**CITY OF MOLALLA
PLANNING COMMISSION MEETING PLANNING COMMISSION
AGENDA**

- 6. PUBLIC HEARINGS**
 - a. SDR02-2024 – Commercial Use Expansion at 220 W Main Street (Davis)
 - b. CUP01-2025 – New Auto Sales Use at 709 W Main ST (Zinder)
- 7. GENERAL BUSINESS**
 - a. New Planning Commission Appointment for Chairman & Vice-Chairman (Wirth)
- 8. STAFF COMMUNICATION**
- 9. COMMISSION COMMUNICATION**
- 10. ADJOURN**

Date: December 30, 2025, for January 7th, 2026, Planning Commission Meeting

1 EXTERIOR ELEVATION - STREET FACING

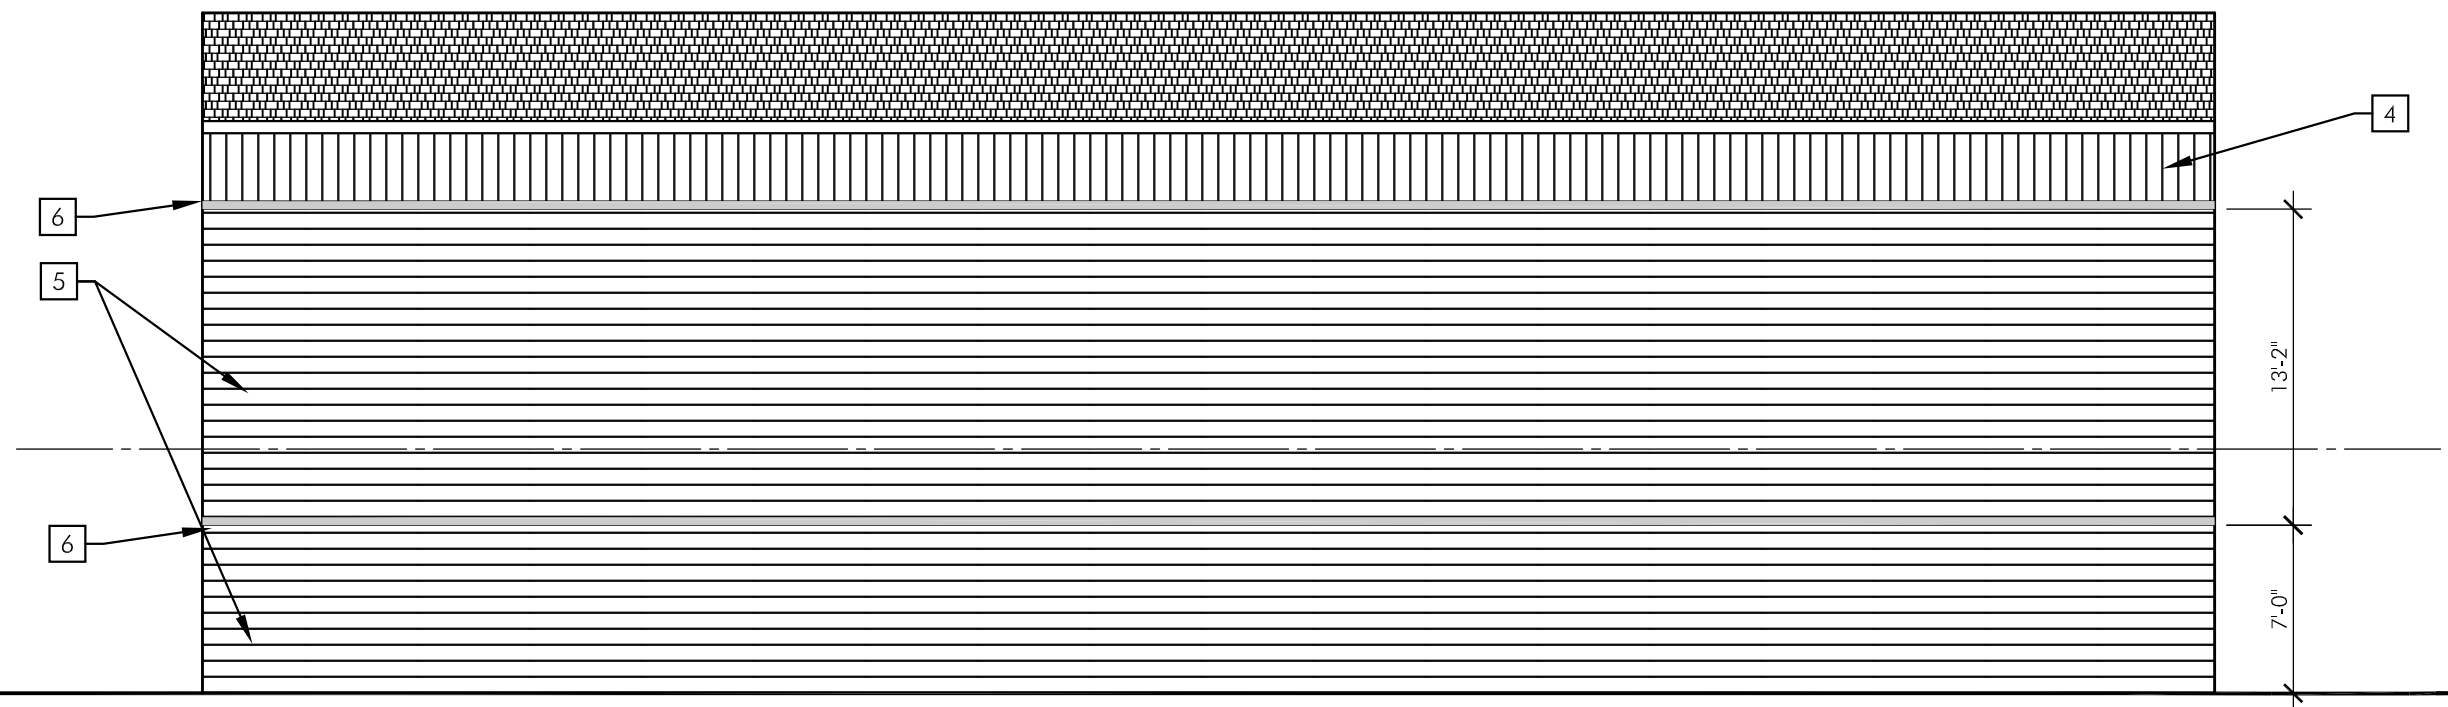
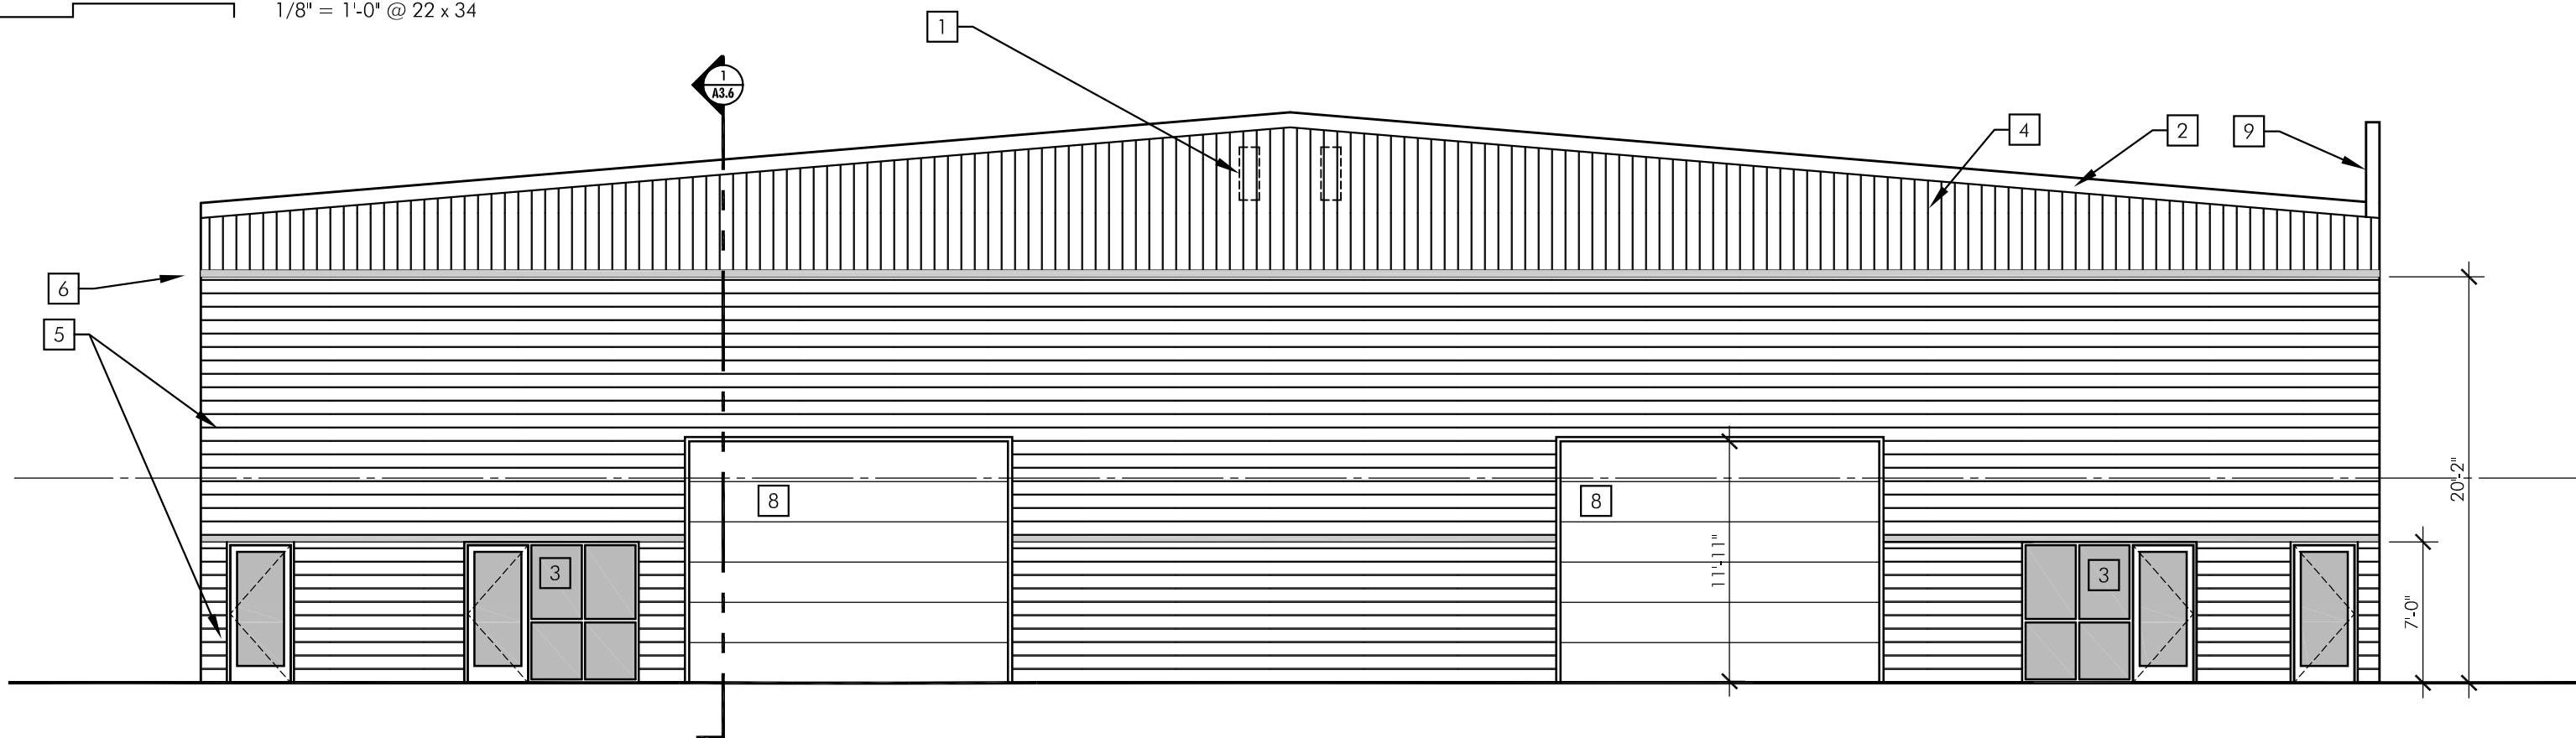
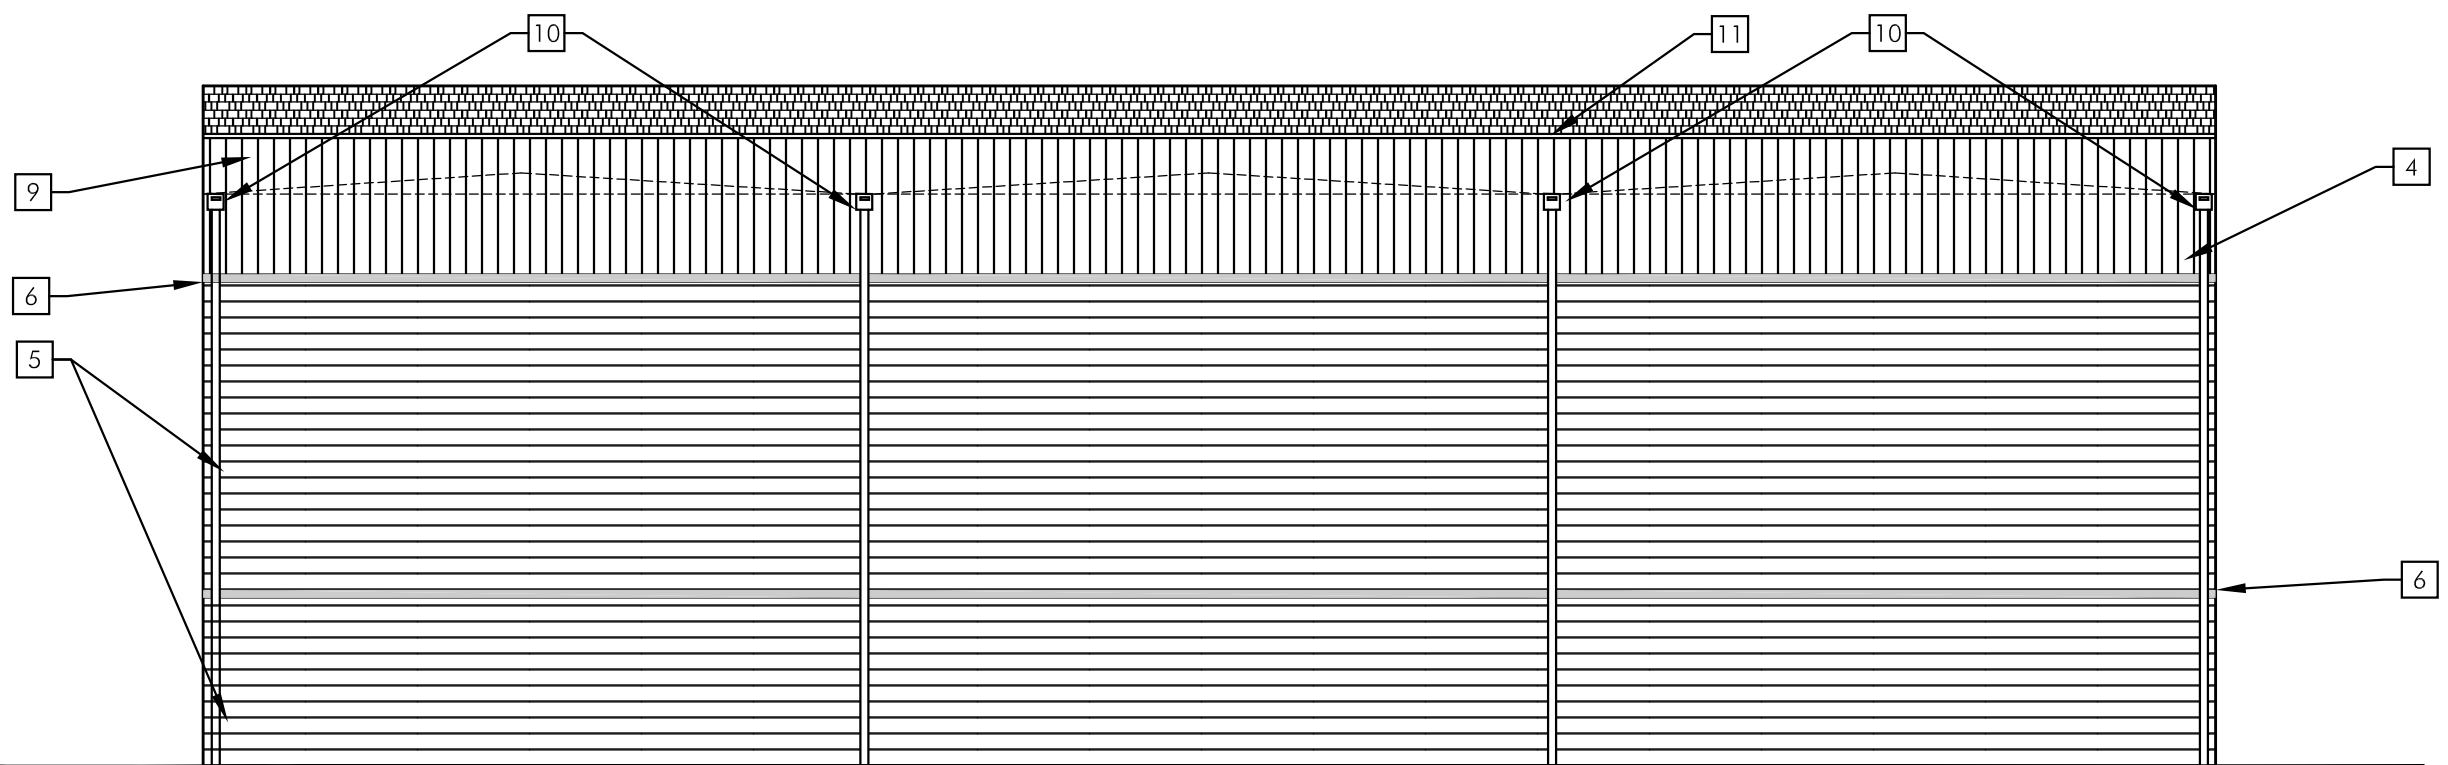
The Applicant's proposal brings the building façade into greater conformance with the provisions of Section 17-3.2.040. Notably, the Applicant's proposal substantially increases total window coverage and creates horizontal and vertical breaks. Additionally, there will be 4 new entrances along the Main Street frontage (for a total of 5 entrances). The applicant is proposing to replace the existing metal siding with a mix of fiber cement and metal siding to achieve a modern look. These elements bring the existing building into greater conformance with these criteria.

1 SITE PLAN
0' 10' 20' 30' 60' 90' 1 : 30 @ 22 x 34

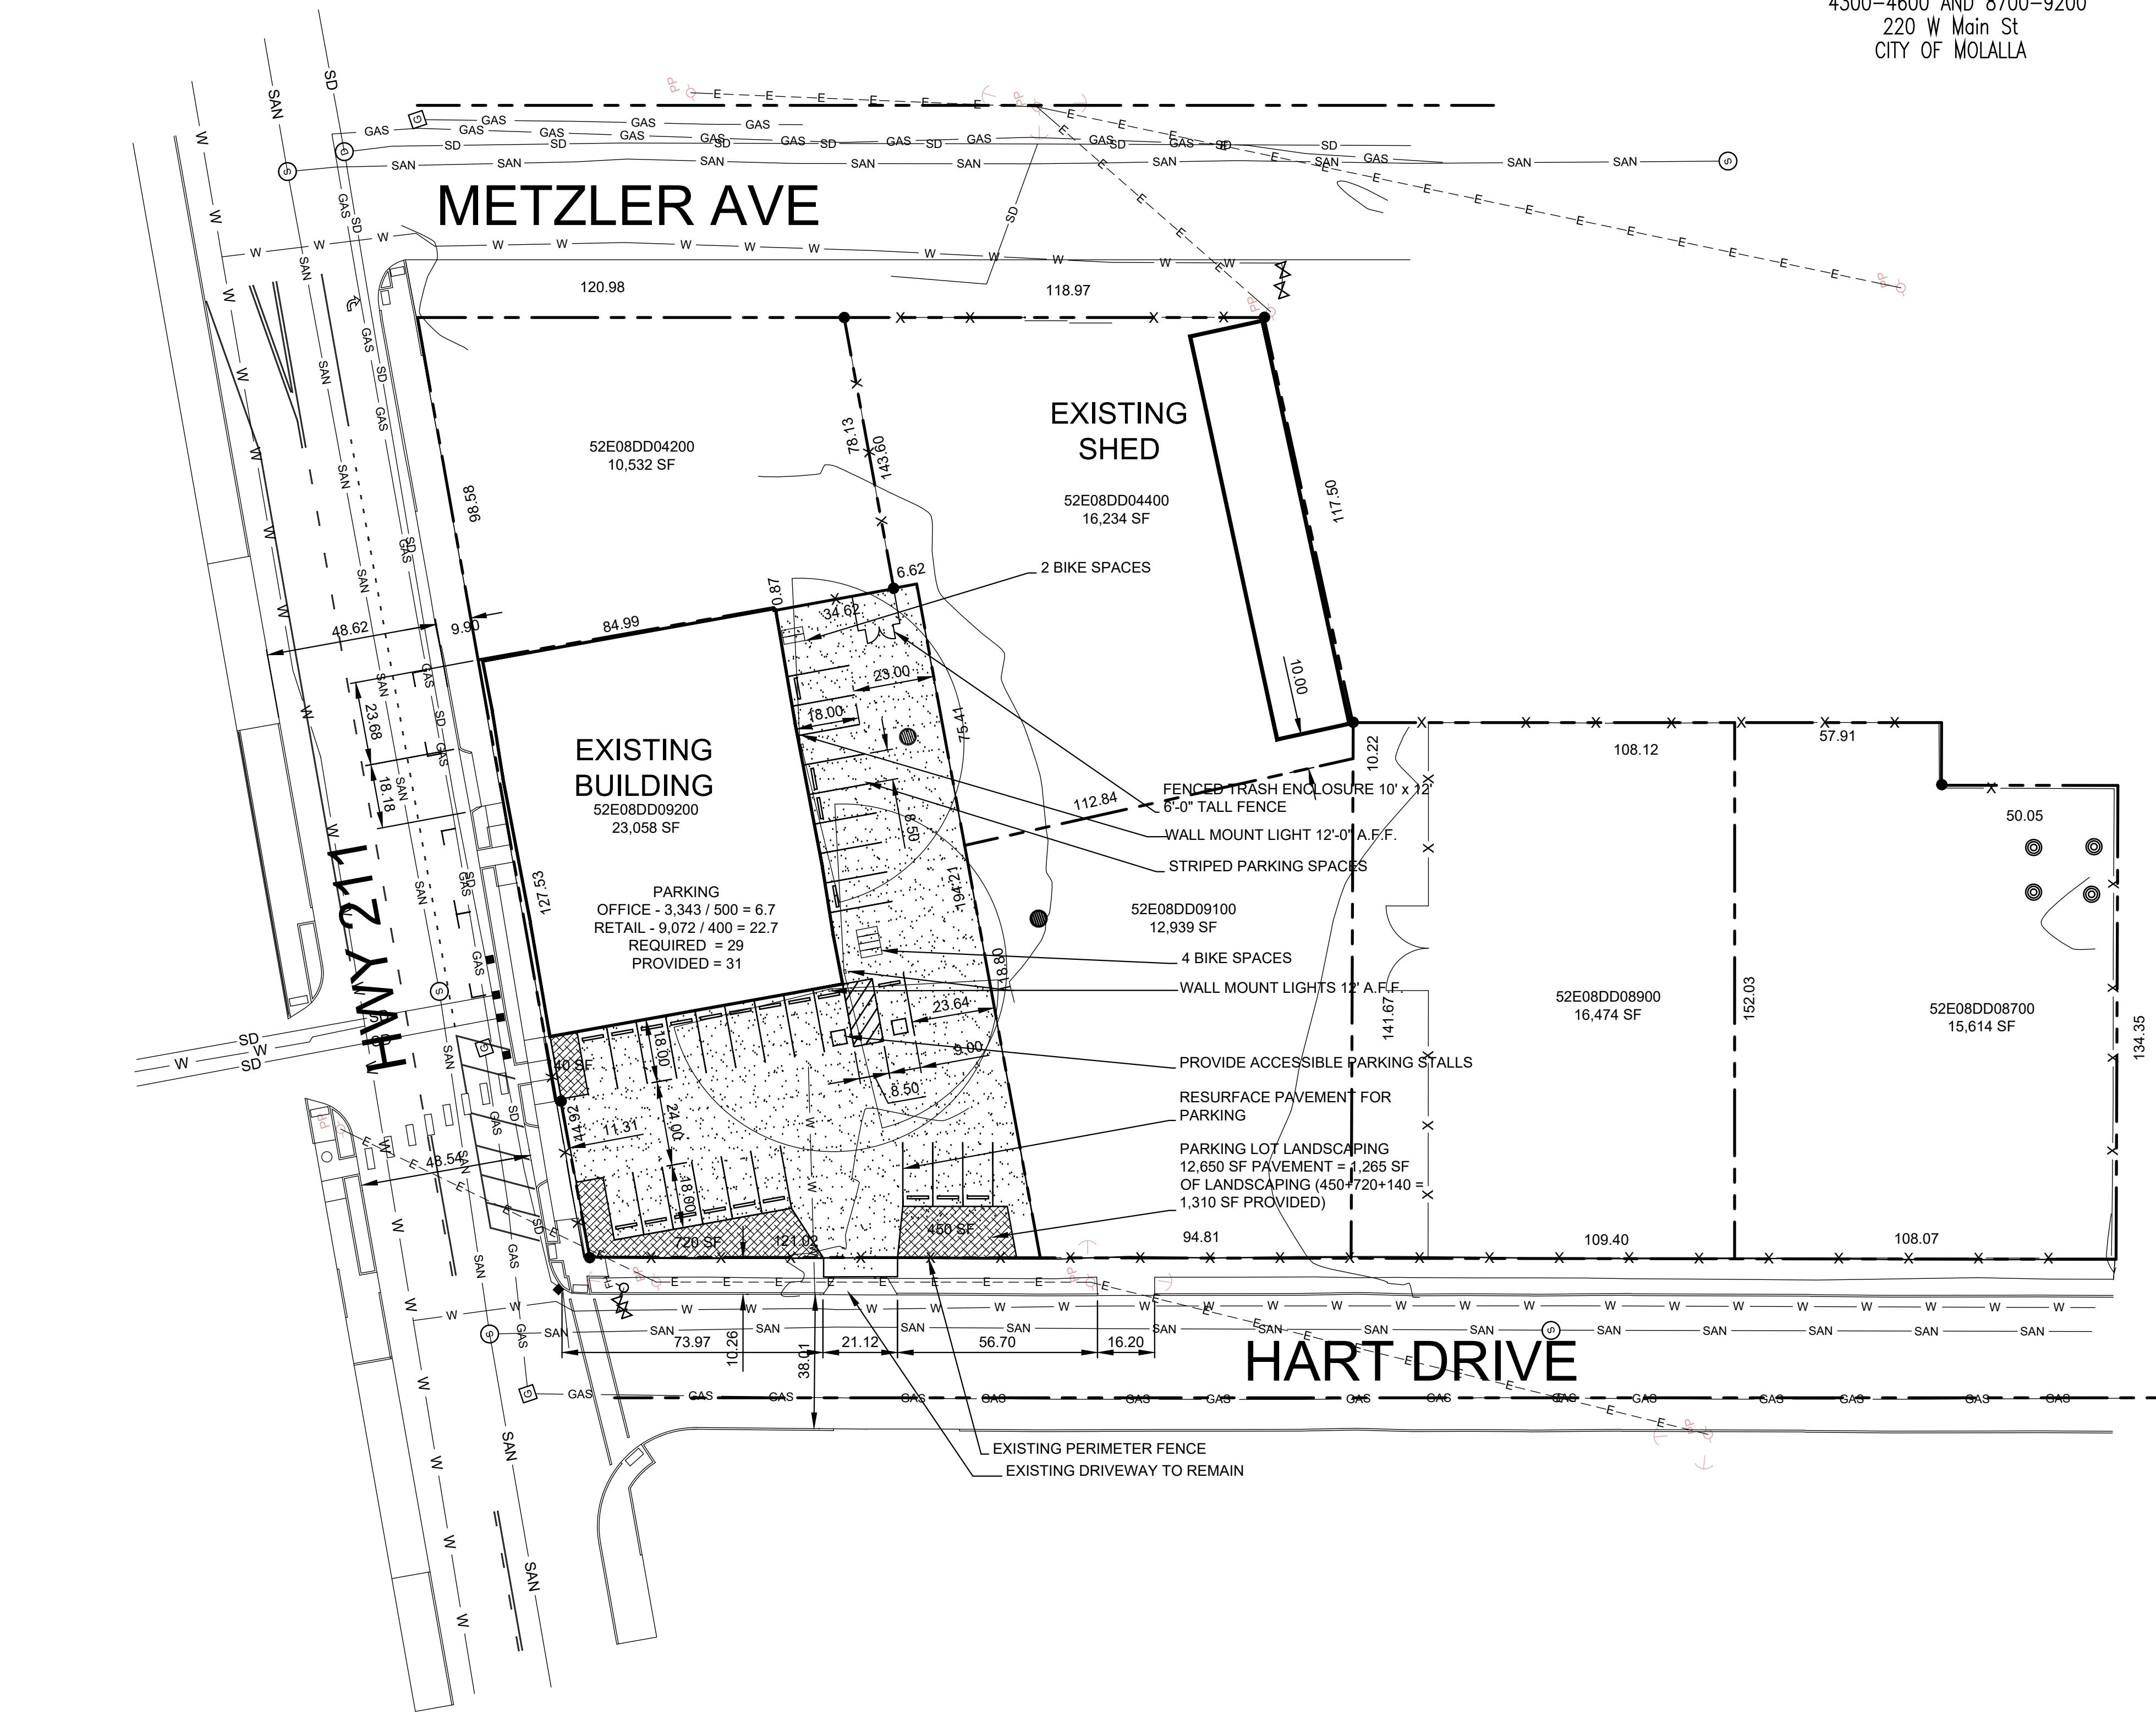
- G. The pedestrian area outside the rear entrances shall be marked and clearly designated from driving surfaces.
- H. The applicant shall meet all accessibility requirements where they coincide with an accessible route and provide parking consistent with ADA requirements (MMC 17-3.5.030 H).

- I. The applicant shall show screening of the 9 parking stalls facing Hart Avenue in compliance with MCC17-3.4.030.E.2.
- J. The proposed location for the bike racks may not be optimal for convenience or usage and may create conflicts with interior pedestrian circulation. Staff offers the opportunity to work with the applicant for an alternative placement.

Findings: The Applicant's submitted site plan shows a 21' driveway width. Molalla Public Works Detail Drawing R-1095 Commercial Driveways requires a driveway width between 30-40 ft for commercial driveways. As a condition of approval, the applicant shall redesign and construct the driveway approach from Hart Ave in accordance with the Molalla Public Works Standards, prior to Civil Review. With the proposed condition of approval, this standard could be met.

Exhibit 3: Arterial (Downtown District) Cross Sections

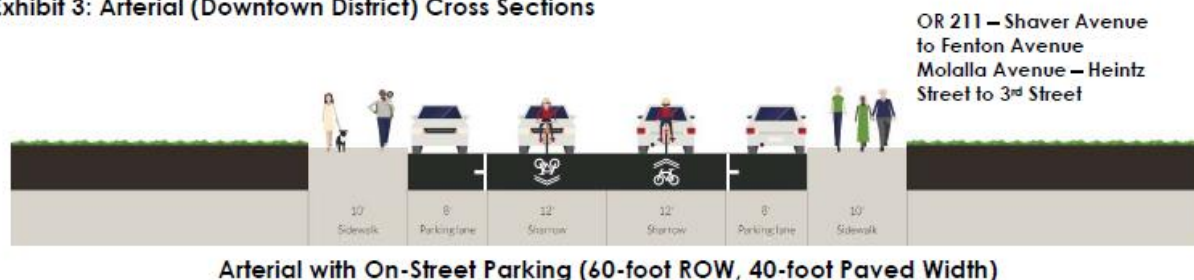
- Closure of the two existing access to the highway. The applicant should be required to build sidewalks in place of the accesses to match the existing sidewalks. An ODOT Miscellaneous Permit is required for this work.
- The applicant shall donate right of way to ODOT for the sidewalks since they are used by the public.
- ODOT Region 1 Technical Center has reviewed the on street parking identified in the city's Transportation System Plan (TSP) as illustrated in exhibit 3 below and determined that it is acceptable. ODOT supports the city requirement for the applicant to construct half street improvements consistent with the cross section in the city's TSP.

Exhibit 3: Arterial (Downtown District) Cross Sections

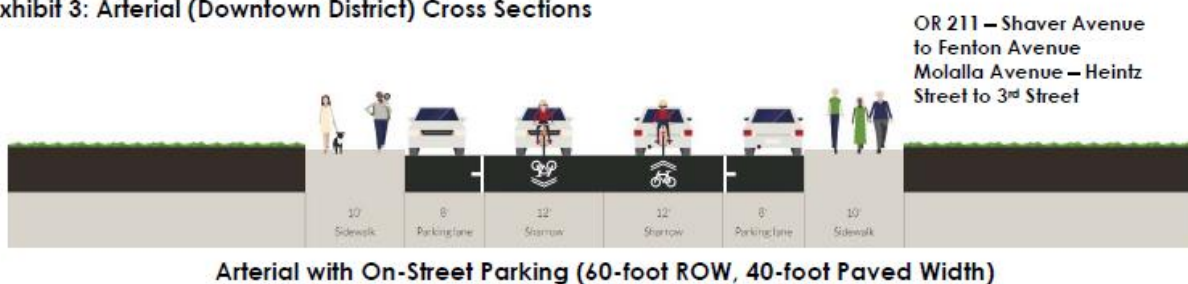
- ☒ The applicant shall construct half street improvements consistent with the city's Transportation System Plan cross section as shown below:

Improvements shall be consistent with ODOT Highway Design Manual, ODOT Traffic Manual, and Americans with Disabilities Act (ADA) standards.
